Futex (Bangladesh) Garment Manufacturing Co., Ltd.

03 February 2025

Structural Inspection Report

Dining Shed (No details for the
UGWR)

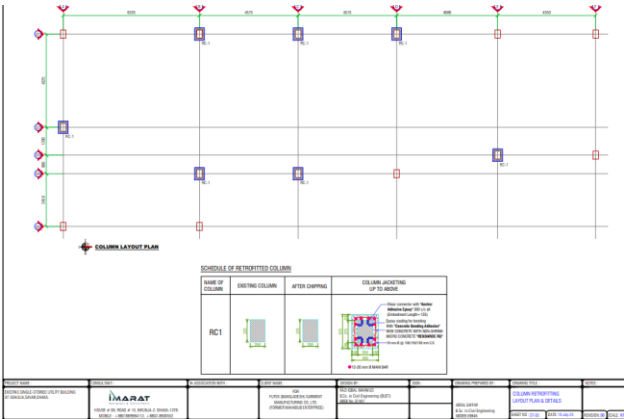
New Steel Pipe Column
size

The retrofitted pipe diameter was
found 75 mm instead of 100mm

Description: A set of retrofitting drawings was found during the inspection, and some remedial works were executed as per the retrofitting drawings. However, no design report was found during the inspection. New steel pipe column was found dia 75 mm instead of dia 100 mm. Also, no information was found in the as-built drawing for the UGWR under the dining shed.

The factory is required to survey the full structure, prepare accurate as-built drawings, reassess the design documents, and submit them to RSC for further review.

Observation-6: Mismatches in as-built drawings (Dining & Fire pump, Medical & Female Prayer Shed, Office Shed, Chemical & Wastage Shed, Security Shed).

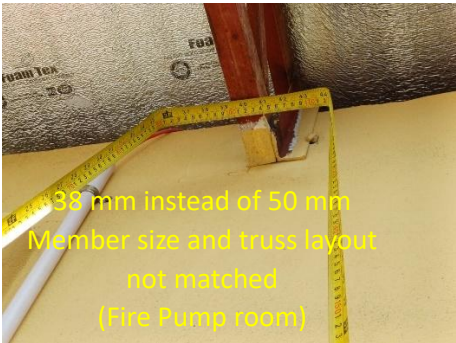
Steel pipe 75 mm instead of 100 mm (Dining Shed)

38 mm instead of 50 mm Member size and truss layout not matched (Fire Pump room)

Thickness 3 mm instead of 5 mm (Medical & Female Prayer Shed)

Member size and rafter layout not matched (Office Shed)

Connection details and rafter layout not matched (Chemical & Wastage Shed)

Member size and rafter layout not matched (Security Shed)

Description: Beam size, steel member sizes and rafter layout did not fully match with the provided as-built drawings. A building engineer is required to survey the full structures and prepare accurate drawings.
